TO: Mercedes-Benz Dealer Principals, General Managers, Sales Managers, Service Managers, Parts Managers	FROM: Gregory Gunther, Department Manager, Vehicle Compliance and Analysis, Engineering Services
RE: Recall Campaign Launch Notification Water Ingress into Right Side of Passenger Compartment MY20 167 (GLE-Class)	DATE: July 12, 2019

Recall Campaign Launch Notification			July 12, 2019
Campaign No. :	NHTSA ID	Campaign Desc. :	Right Side Water Ingress
2019060007	19V459	19P6190203	
<p>This is to notify you of a new Recall Campaign regarding the potential for water ingress into the right side of the passenger compartment on 753 Model Year (“MY”) 2020 GLE-Class (167 platform) vehicles. The recall campaign will be visible on the www.safercar.gov website and may generate questions from customers. Affected VINs will be flagged in VMI as “OPEN” on July 12, 2019.</p>			
Background			
Issue	<p>Daimler AG, the manufacturer of Mercedes-Benz vehicles, has determined that on certain Model Year (“MY”) 2020 GLE-Class vehicles (167 platform), a welding stud on the main floor may not have been welded according to specification. As a result, a small hole may be present in the main floor in the vehic

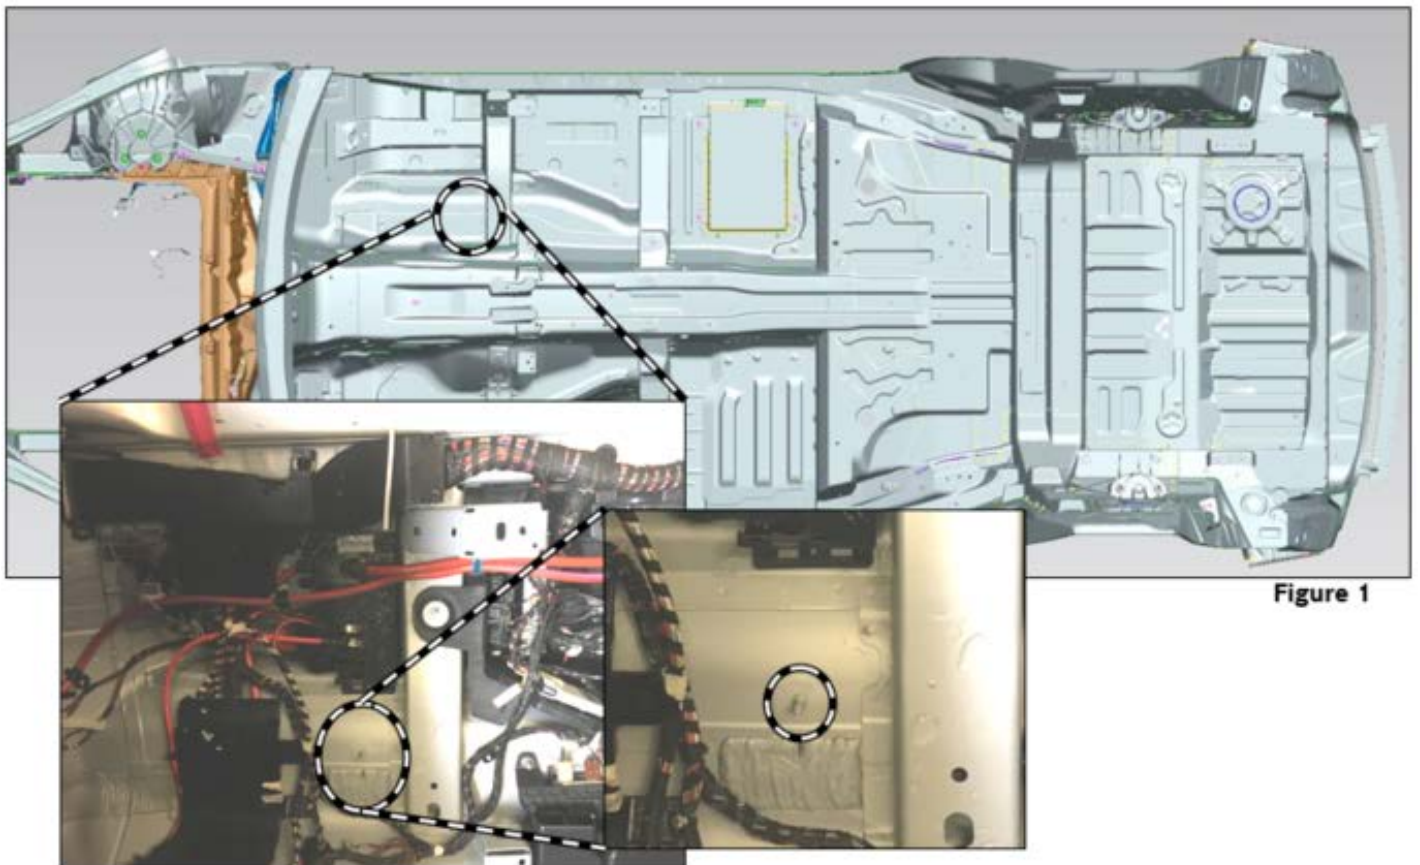
1. Remove right front floor covering.
i For basic data, see **AR68.80-P-0008ME**.
2. Remove wear protection cover.
i For basic data, see **AR54.15-P-1351ME**.
i The wear protection is marked as number 3 in the AR document.
3. Seal weld studs on vehicle floor in right footwell all around (**Figure 1**).
i Observe drying time of seam seal.
